SERVICE BULLETIN

<u>ENGINE - DIFFUSER CASE ASSEMBLY - REPLACE THE NO. 4 BEARING SCAVENGE TUBE ASSEMBLY - CATEGORY CODE 5 - MOD.ENG-72-0004</u>

Location of No.4 Bearing Scavenge Tube Assembly Fig.1

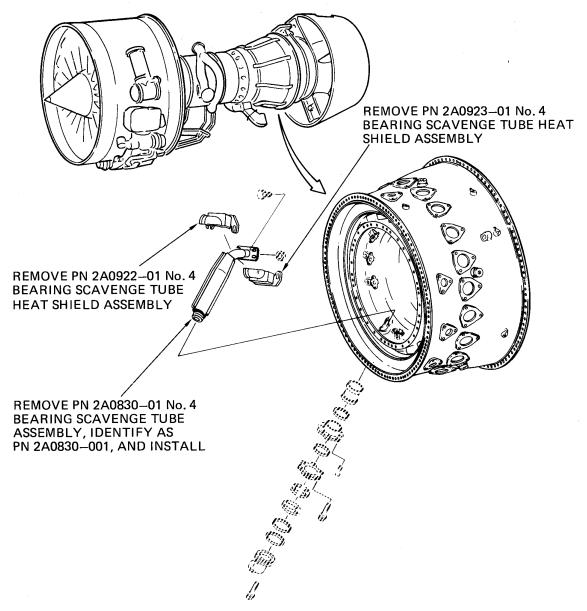
- (a) Set-up and machine the welded tabs (A and B) for the full length of the Heat Shield.
- Refer to Figures 1 and 2.
- (B) Remove the Heat Shield and the Insulation Blanket from the No. 4 Bearing Scavenge Tube Assembly.

Refer to Figures 1 and 2.

Location of No.4 Bearing Scavenge Tube Assembly Fig.2

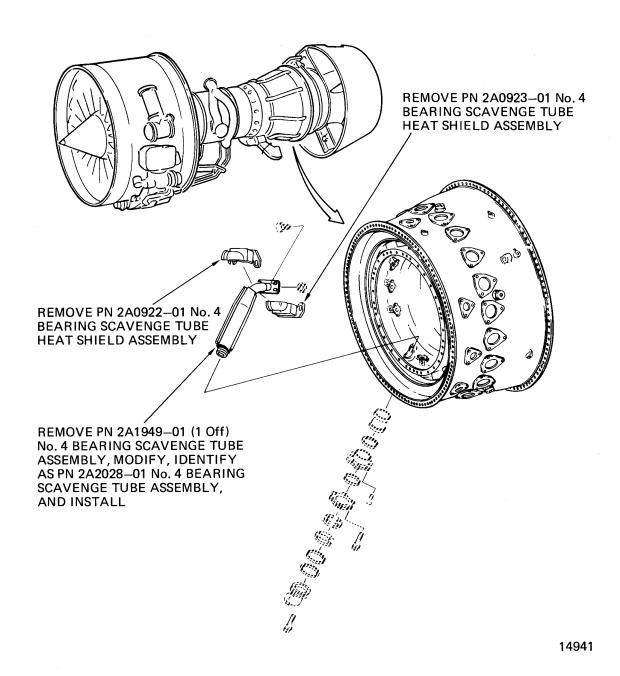
- (a) Set-up and machine the welded tabs (A and B) for the full length of the Heat Shield.
- Refer to Figures 2 and 3.
- (b) Remove the Heat Shield and the Insulation Blanket from the No. 4 Bearing Scavenge Tube Assembly.
